AGENDA ITEM SUMMARY REPORT

APPLICATION: Coastal Development Permit 2-22 (CDP 2-22), Design Review 7-22 (DR 7-22); Parcel Merger 1-2022 (MGR 1-22), Application Date 3-14-2022

REQUEST: Coastal Development Permit, Design Review and Parcel Merger to construct a Grocery Outlet Market (retail store). As proposed the Project would include the demolition of an existing 16,436 SF vacant former office building and associated 55-space parking lot and wooden fencing along the property line, and the construction and operation of a 16,157 SF, one-story, retail store with a 55-space parking lot and associated improvements and infrastructure. The Project would be operated by 15 to 25 full-time staff and two (2) managers and would be open from 9:00 a.m. to 10:00 p.m., seven days per week.

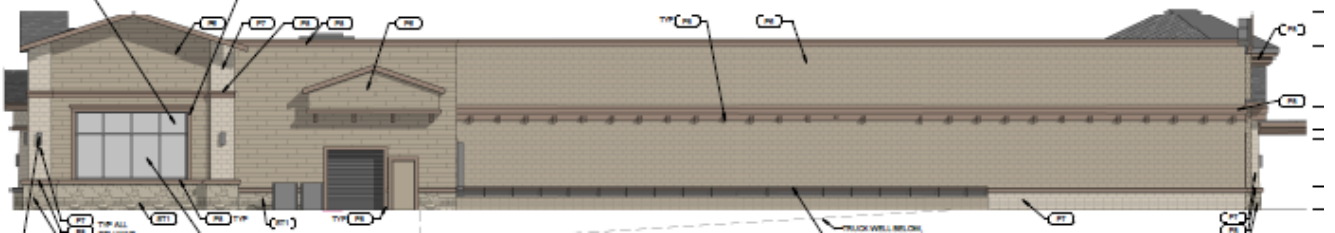
1. The roof Parapet does not “include detailing typical of Fort Bragg’s character and design.” The proposed Project does not use much architectural detailing on the parapet. The Planning Commission can recommend optional Special Condition 22.

The Planning Commission may recommend Optional Special Condition 24 to change the design so that the building materials on the North and East façade of the building match that of the south face.

Planning Commission may also consider optional Special Condition 25 to require a similar level of material finishes for the Western elevation of the building. While a lower level of architectural finish is generally acceptable on the back side of the building, the Planning Commission may choose to require hardipanel on this elevation.

Optional Special Condition 22: The Applicant shall submit a revised design that includes additional detailing in the parapets for consideration and approval by the Community Development Director.

Optional Special Condition 24: The Applicant shall replace/cover all smooth surface CMU block on the east and north elevation of the building with the higher grade materials (fish scale hardipanel) which are proposed for the South and West facade of the building.

Optional Special Condition 25: The Applicant shall replace/cover all CMU block on the west face of the building with hardiboard composite wood paneling.
